BID NUMBER #25232

Project: Saunders Road Sanitary Sewer and Lift Station Improvements for Lake County Public Works Department

Subject: Addendum #1

Date: August 15, 2025

PIPE BEDDING AND
TRENCH BACKFILL
(LCPW STANDARD DETAIL 3)

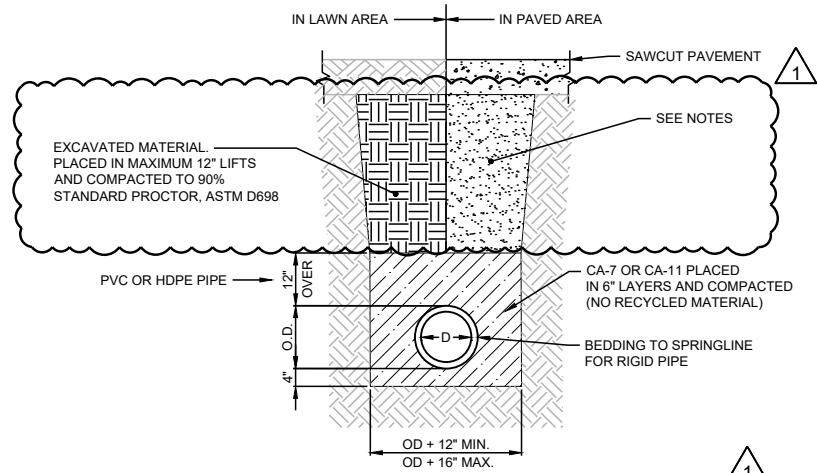
2. Question: Can you confirm what type of material will be required for trench backfill? It appears that you will require flowable fill and we just want to confirm that this is what you will require. Flowable fill backfill will add a substantial cost to the project compared to conventional material typically used for similar projects. Will flowable fill also be required for backfill around the wet well and valve vault?

Answer: Flowable fill is required beneath pavement and shoulder replacement on Saunders Road. Granular fill (crushed stone, IDOT gradation CA-6) is required beneath paved areas (HMA pavement, sidewalks, curb & gutter, and equipment pads) at the lift station site. Excavated trench material may be used for backfill in unpaved areas.

1. CONFIRM REQUIREMENTS OF LOCAL MUNICIPALITY AND ROADWAY AUTHORITY REGARDING THEIR SPECIFIC BEDDING AND BACKFILL MATERIAL STANDARDS.
2. FLOWABLE FILL / CONTROLLED LOW STRENGTH MATERIAL (CLSM), MIX 3 PER ARTICLE 1019.05 OF THE IDOT STANDARD SPECIFICATIONS REQUIRED BENEATH SAUNDERS ROAD PAVEMENT AND SHOULDERS.
3. GRANULAR FILL (CRUSHED STONE, IDOT GRADATION CA-6) REQUIRED BENEATH PAVEMENT, SIDEWALKS, EQUIPMENT PADS, AND CURB & GUTTER AT THE LIFT STATION SITE.
